Office Action Summary	Application No. 10/593,784	Applicant(s) SUZUKI ET AL.	
	Examiner Jeffrey R. West	Art Unit 2857

DETAILED ACTION

FIG.6

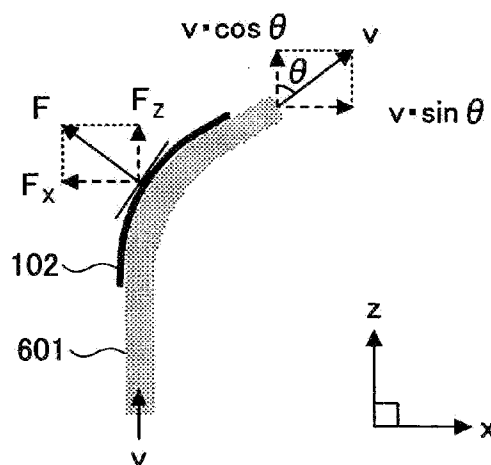
The Examiner first draws Applicant's attention to the instant specification which describes the inherent force vectors that result from an upward force being applied to a curved inclined side surface:

The Examiner asserts that, as can be seen by the citation and Figure provided above, a first horizontal/perpendicular force F_x is created due to a vertical force

impacting a curved inclined side of a receiver. This force is inherently generated anytime a vertical force impacts such a curved inclined side of a receiver.

Figure. 1 Concept.

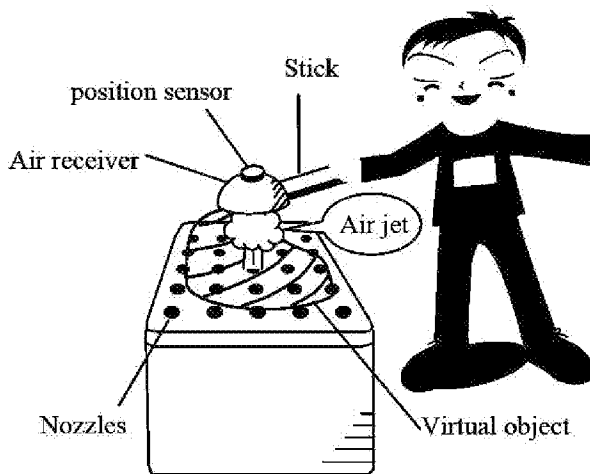
Turning to Suzuki, Suzuki discloses a receiver with such curved inclined sides that is impacted by such vertical forces:

Therefore, the Examiner asserts that one having ordinary skill in the art would recognize that the receiver of Suzuki does convey a force in a "direction perpendicular to a direction of the jetting gas or liquid".

Additionally, since the receiver of Suzuki has two opposing curved inclined sides that are both impacted by vertical forces, and since the cited portion of the instant specification discloses that such impact of a force on an opposing side of a curved inclined side creates an opposing horizontal/perpendicular force, one having ordinary skill in the art would recognize that the receiver of Suzuki does provide a

force in first and second directions of force with "the first direction and the second direction being perpendicular to the direction of the jetting gas or liquid".
